Lucas Heights Resource Recovery Park Project Response to Submissions and Preferred Project Report

PART 2 - Appendix A & Appendix B & Appendix C

**Lucas Heights Resource Recovery Park Project (SSD_6835)
Response to exhibition of Environmental Impact Statement**

Expected depth of waste

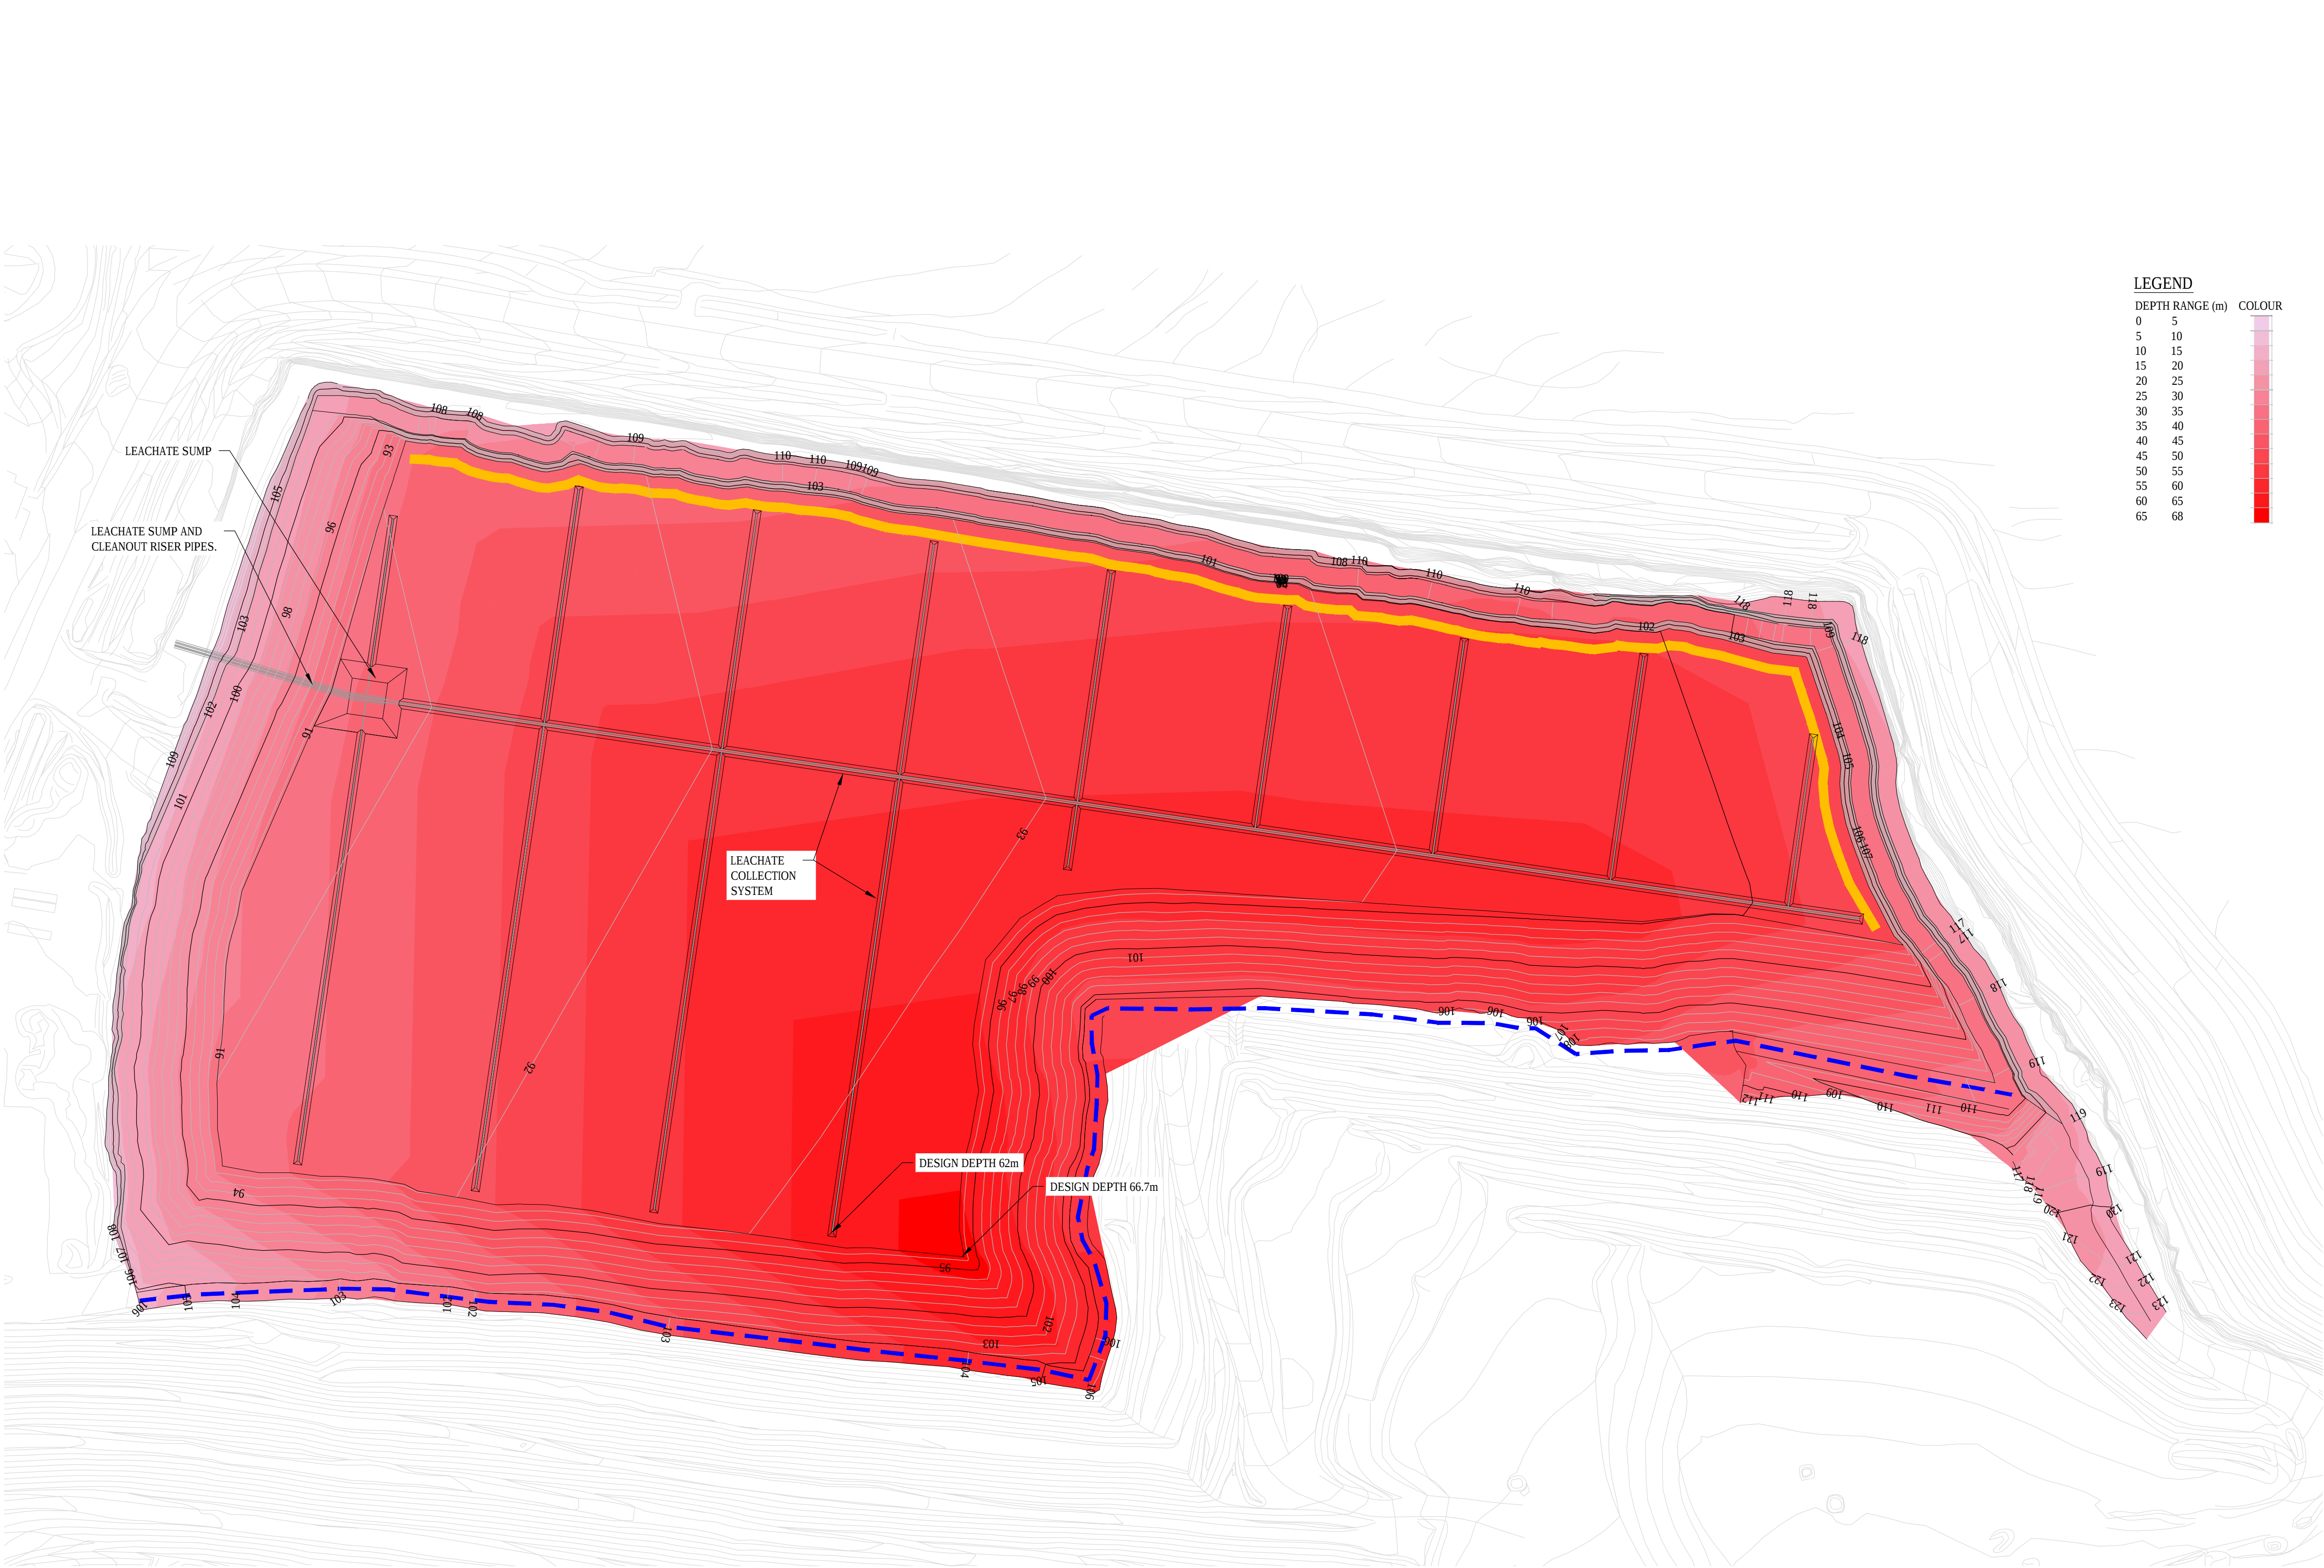
- a) The EPA requests the Proponent provide the proposed height of Cell 5.2 and Cell 5.3 from the base of the cell to the proposed final landform?

A contour map of the expected depth of waste over Cell 5.2 and Cell 5.3 is attached (Drawing 21-20508-SK039, Appendix A). These contours represent the depth between the designed base of the liner (Drawing 21-20508-C003, Appendix B) to the top of the baseline final landform (as shown in Figure 6.2 of the EIS). The maximum proposed height from the base of the liner to the proposed final landform is 66.7 m. It is noted that the maximum height of waste over any leachate pipe is expected to be 62 m.
